**PROPOSED CHANGE NO. 16**

**Date:** November 29, 2023  
**File:** 8.1C-01.4.03  
**Project No.:** 2005  
**Project:** Burlington Central HS Renovation  
**Trade Contract:** General Contractor

**Description: Site Upgrades**

Drawing Title:  
**SITE PLAN**

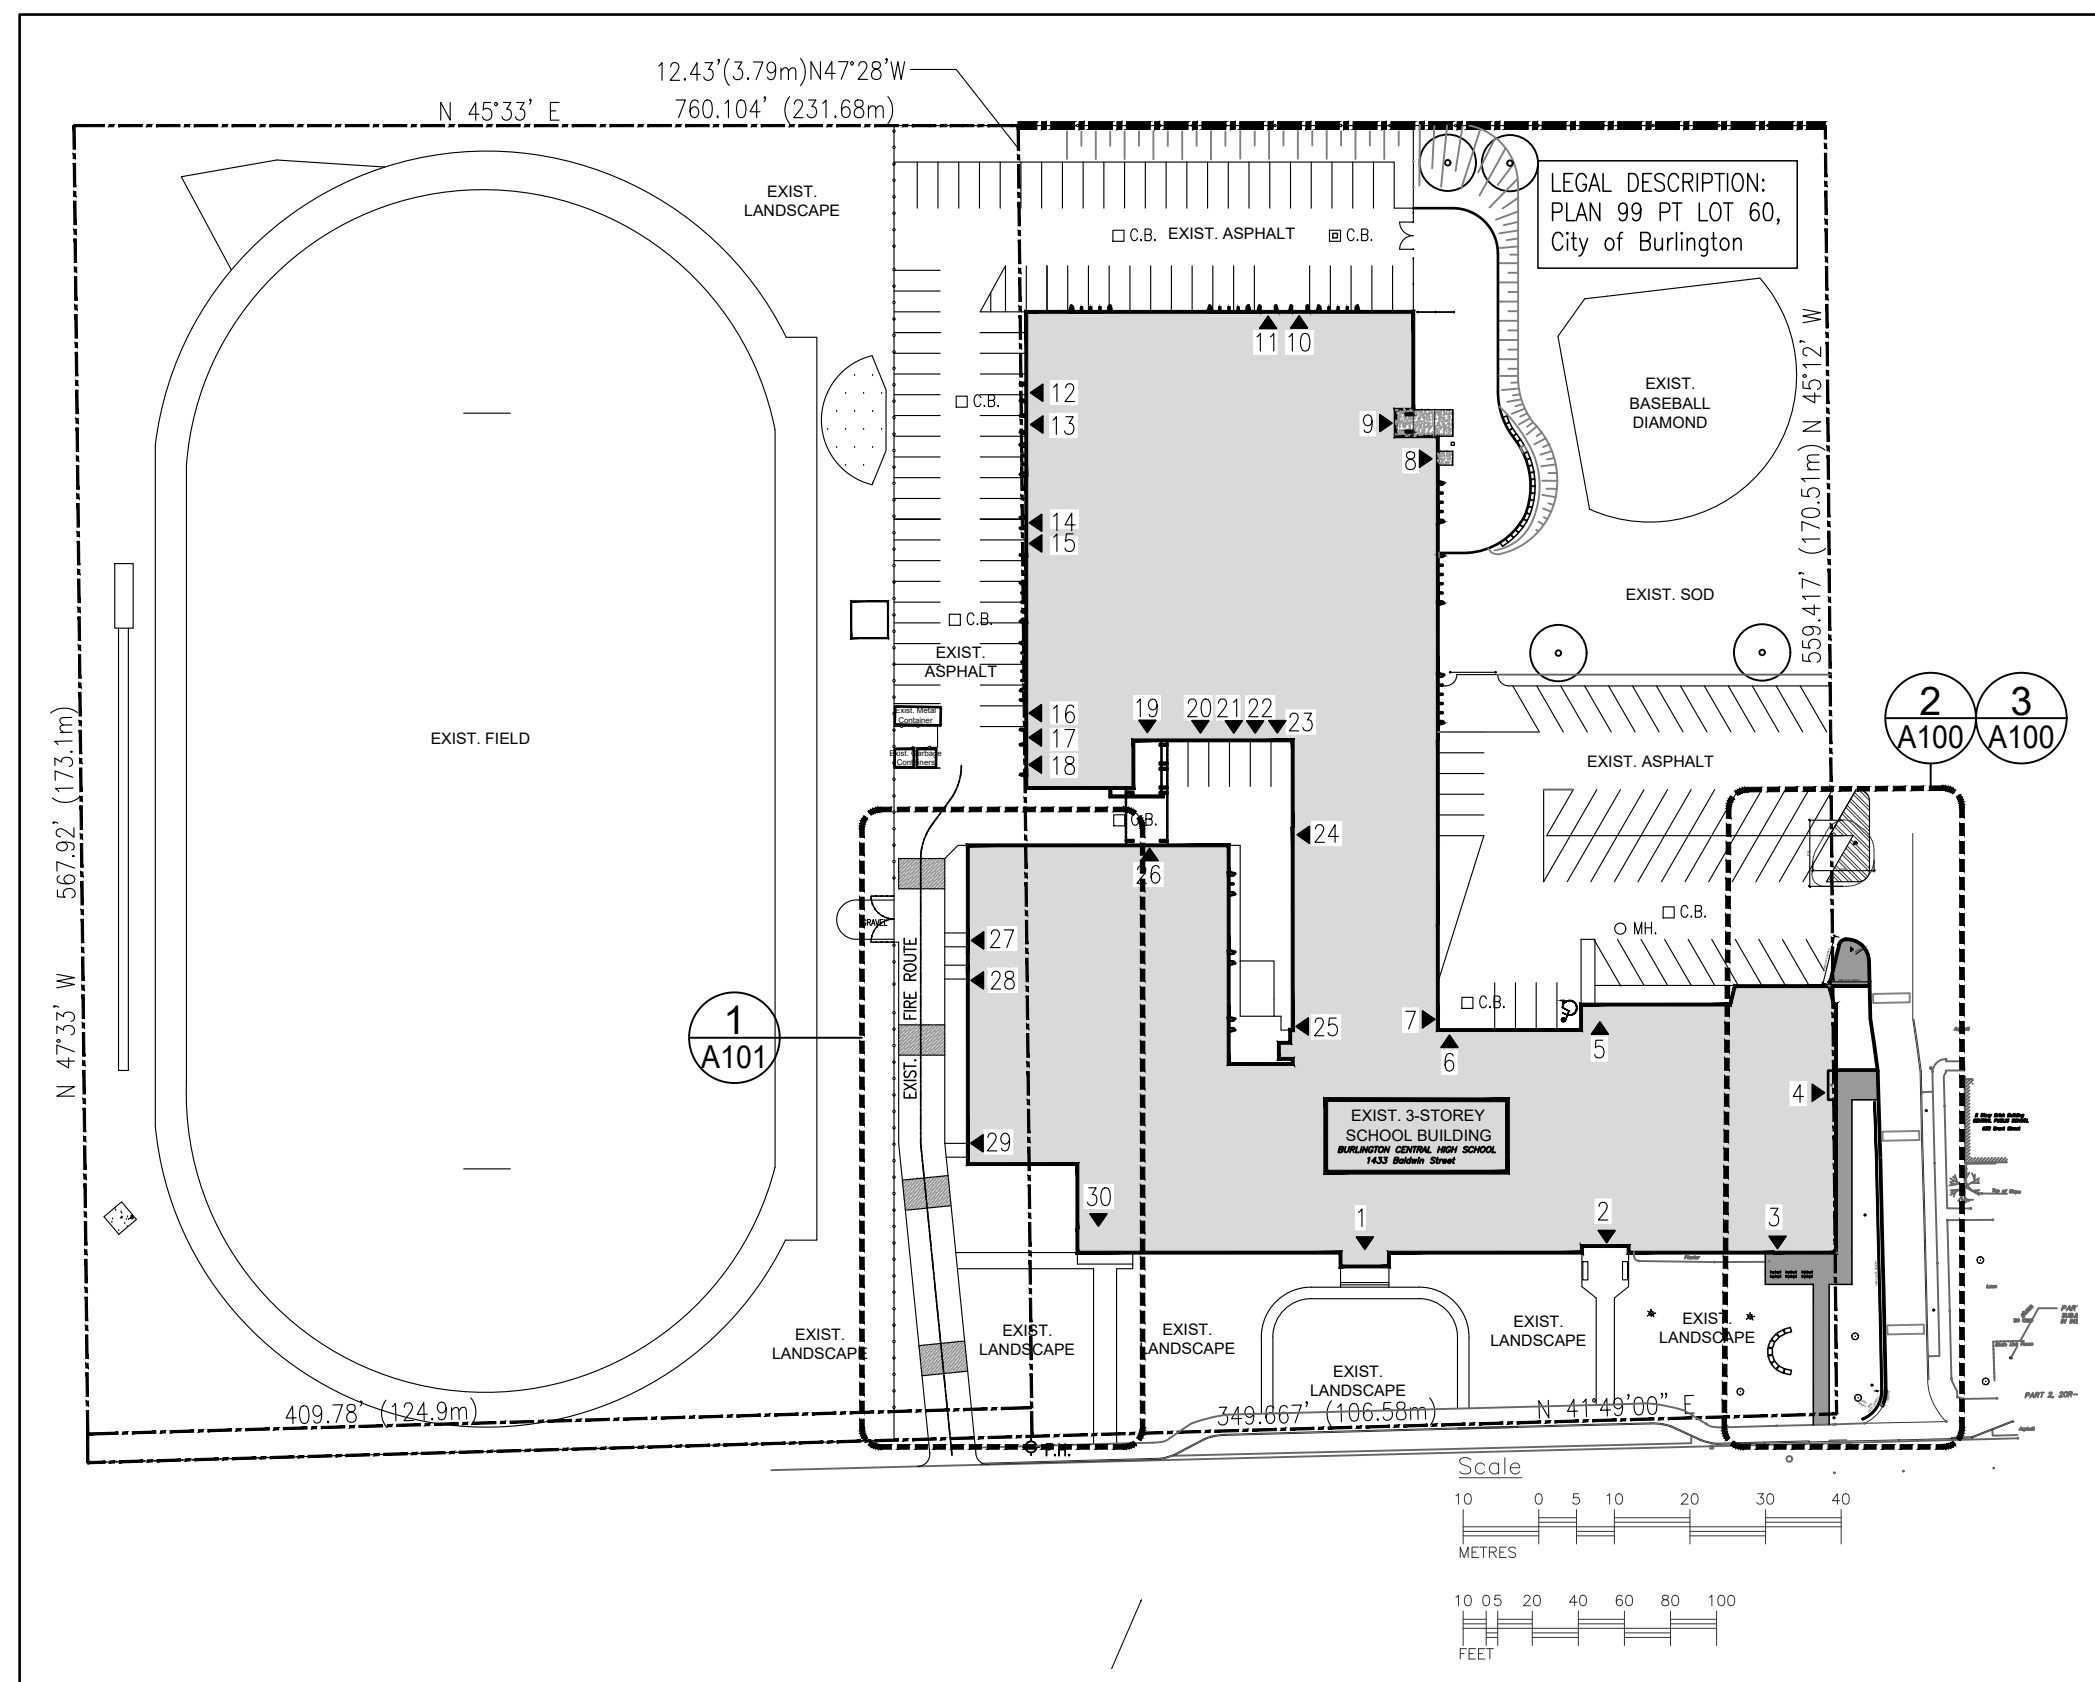
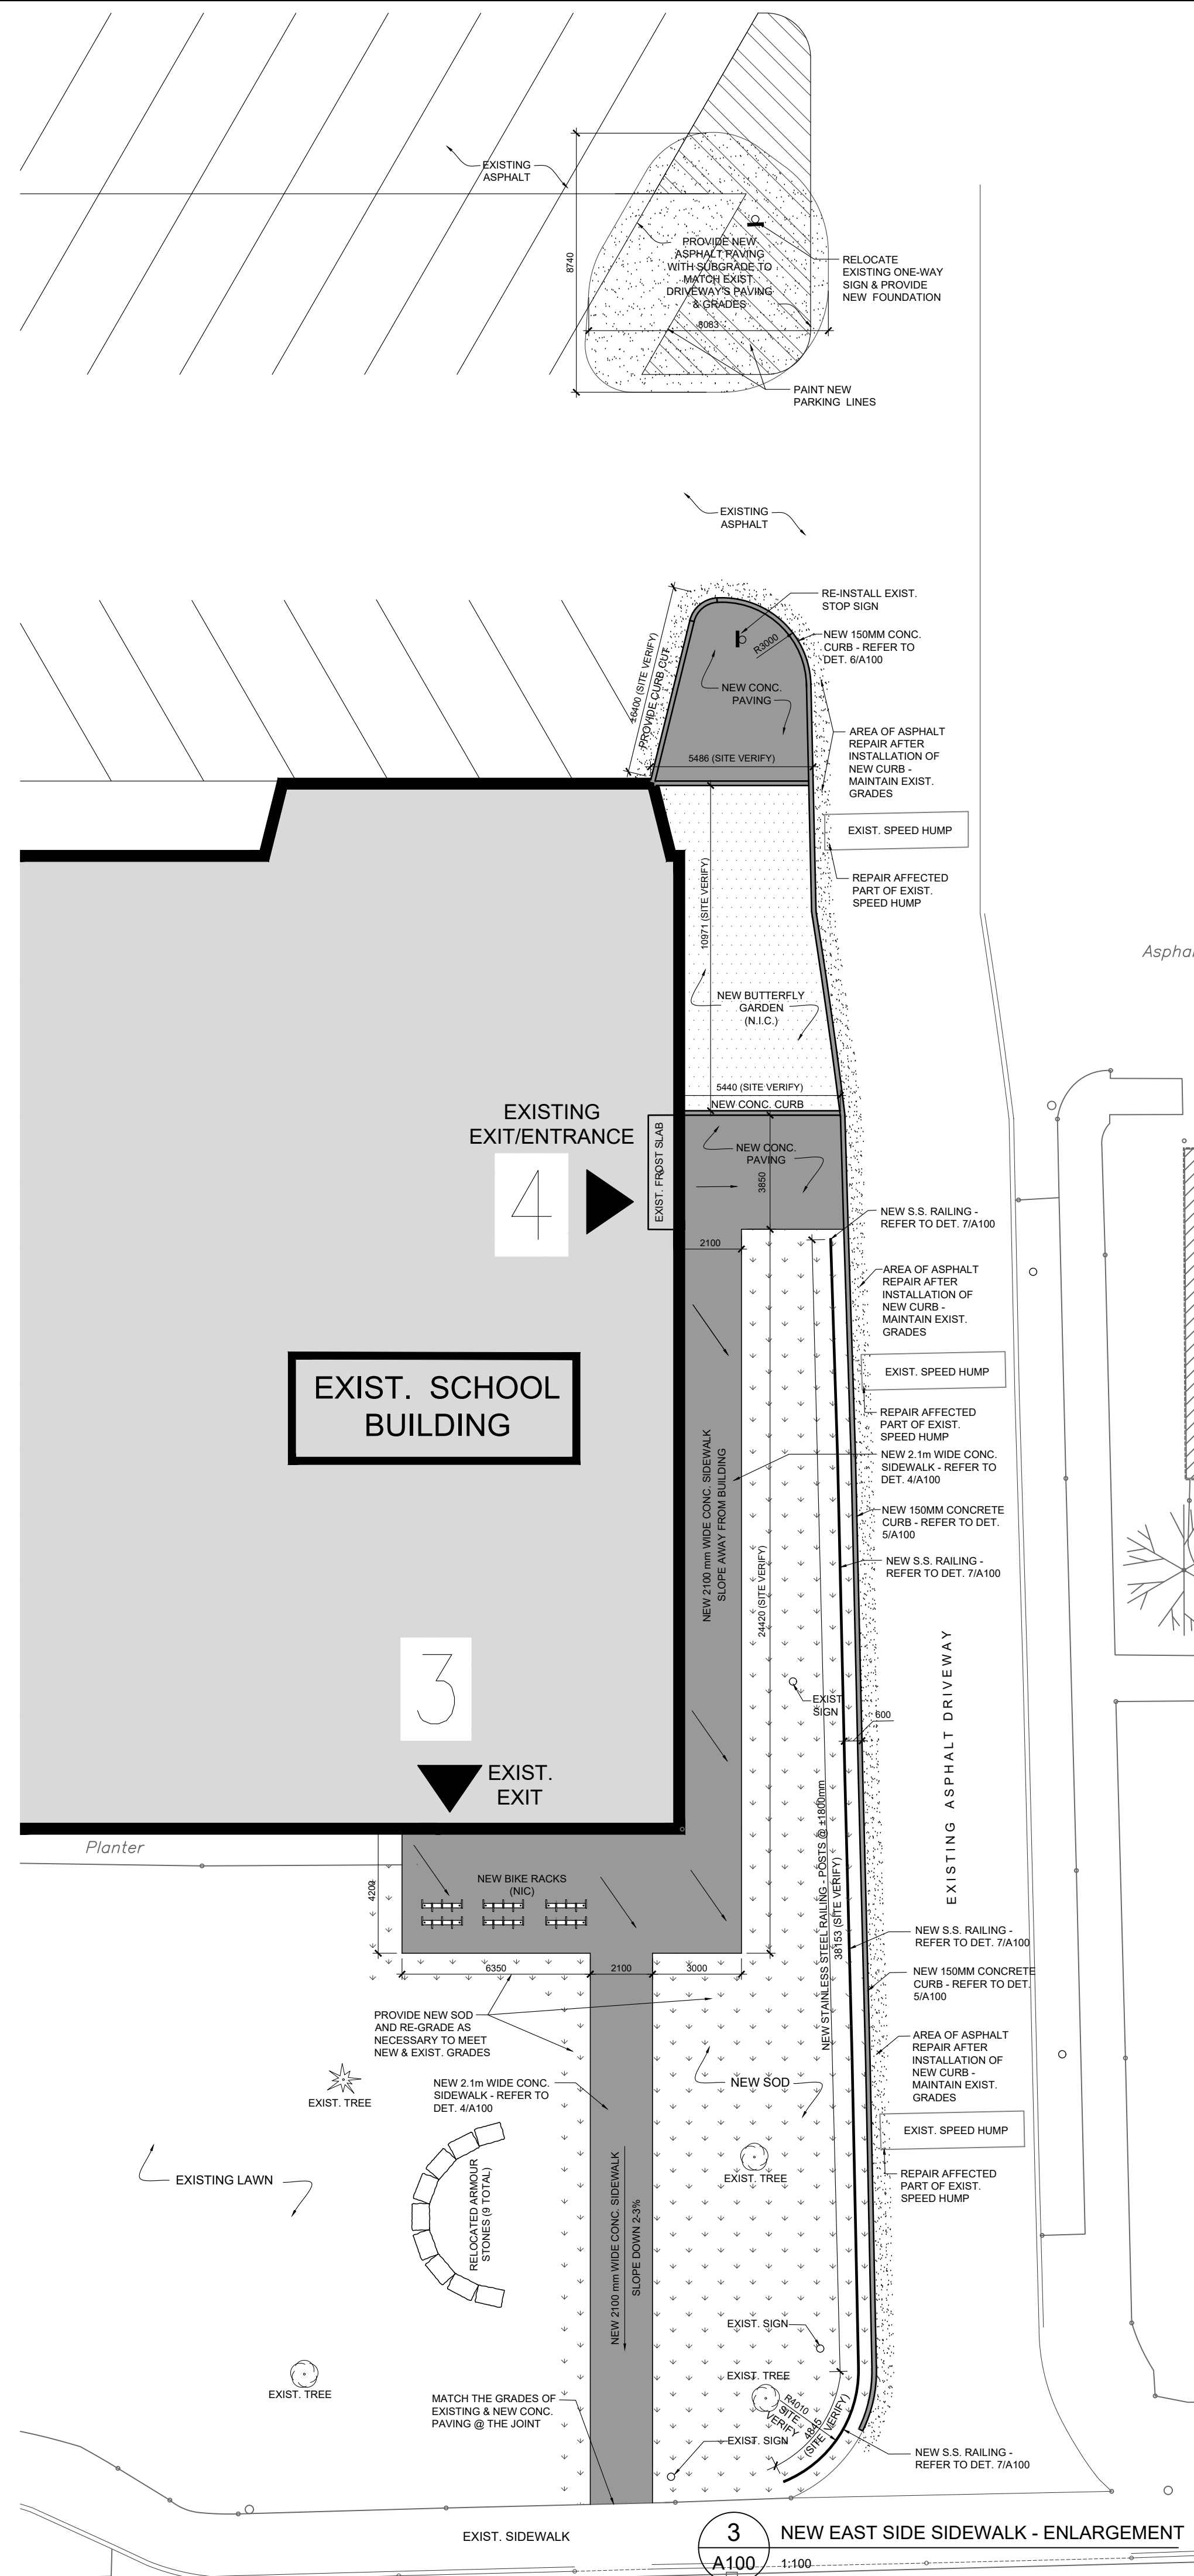
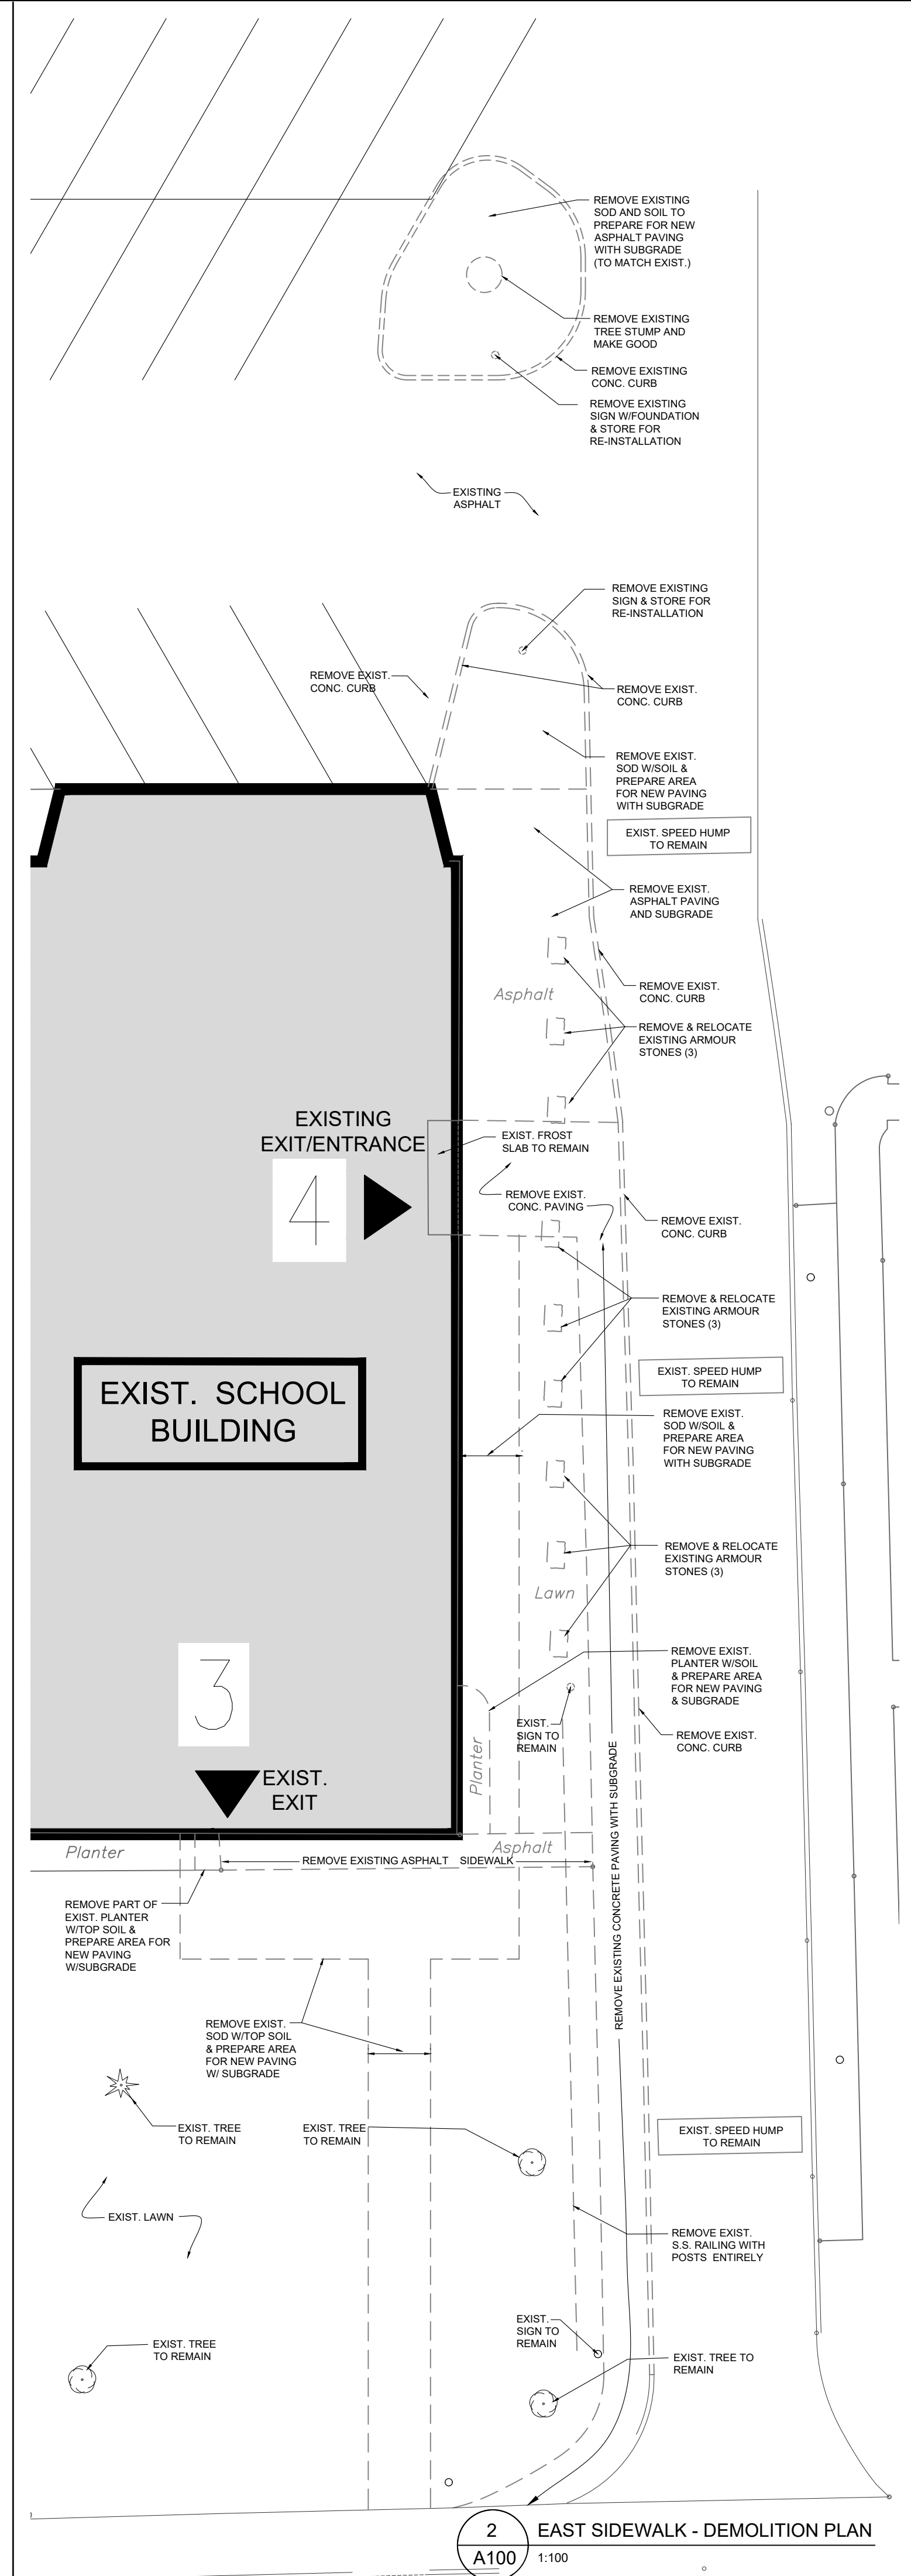
Refer to enclosed A100 Site Plan and A101 Site Plan Enlargement Speed Humps for work which includes;

- Removal of existing sidewalk, curb and railing along the east driveway
- Removal of existing tree stump in the parking lot area
- Removal of existing planter and some lawn areas
- Removal and relocation of 9 armour stones
- Provision of new concrete sidewalk, concrete bike rack pad, and concrete island for garbage bins
- Provision of new concrete curb and repair of existing asphalt driveway and speed humps affected by new work
- Provision of new stainless steel railing along the existing east driveway
- Provision of new asphalt pavement and new painted lines over removed tree stump area
- Provision of soiled area for new butterfly garden (NIC)
- Provision of new speed humps on the existing west driveway
